# Intel<sup>®</sup> Celeron<sup>®</sup> Processor Specification Update

Release Date: December 2006

Document Number: 243748-048

Figure 1 Celeron® on 0.13 Micron Processor 256K Platforms Workaround

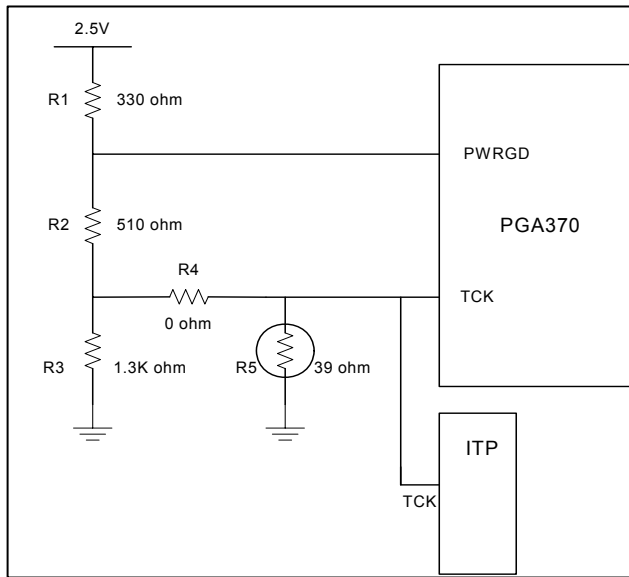
**Workaround:** To prevent the risk of power-on boot failures or catastrophic thermal failures, a platform workaround is required. The system must provide a rising edge on the TCK signal during the power-on sequence that meets all of the following requirements:

Please note, the example workaround circuits attached require circuit modification for ITP tools to function correctly. These modifications must remove the workaround circuitry from the platform and may cause systems to fail to boot. Review the accompanying notes with each workaround for ITP modification details. If the system fails to boot when using ITP, issuing the ITP 'Reset Target' command on failing systems will reset the system and provide a sufficient rising edge on the TCK pin to ensure proper system boot.

In addition, the example workaround circuits shown do not support production motherboard test methodologies that require the use of the processor JTAG/TAP port. Alternative workaround solutions must be found if such test capability is required.
